SILVER SPRING GATEWAY
 SILVER SPRING, MD
 THE JBG COMPANIES

ILLUSTRATION TO PROPOSED CHANGES TO SILVER SPRING SQUARE SIGNATURE SET LANDSCAPE DESIGN
 NOT TO SCALE

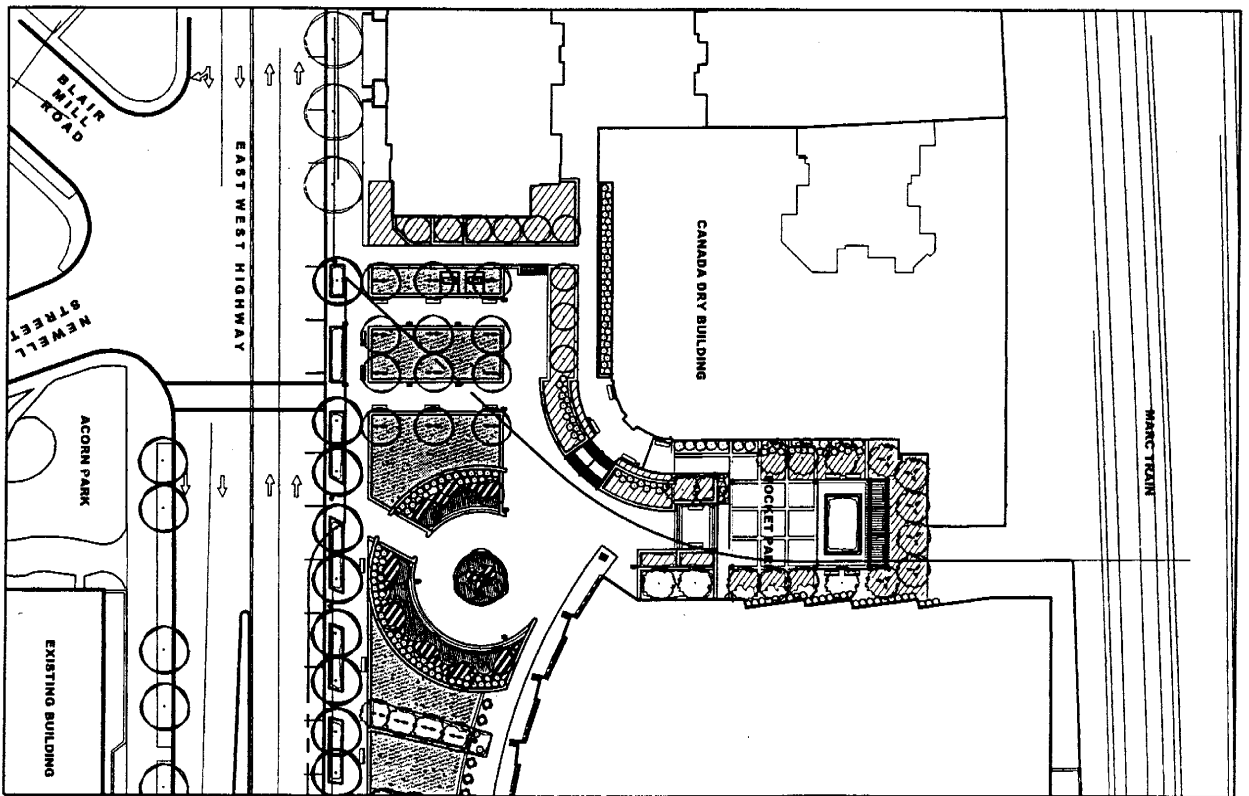
This sheet is intended to illustrate proposed changes to the approved Signature Set landscape design for the Silver Spring Gateway Project as proposed by the Silver Spring Gateway Project Plan, Drawing 1/L.L. - 4.0. It illustrates the approved Signature Set landscape design for the Silver Spring Gateway Project to be constructed if Blair Mill Road is left in place.

Approved with Staff Review of Silver Spring Gateway Project Plan, In drawing two, Blair Mill Road is abandoned and the land is incorporated into both the Silver Spring Square and Silver Spring Gateway projects. The Silver Spring Gateway Project Plan proposes a large urban public plaza space and a smaller pocket park, both of which straddle the property line dividing the two projects.
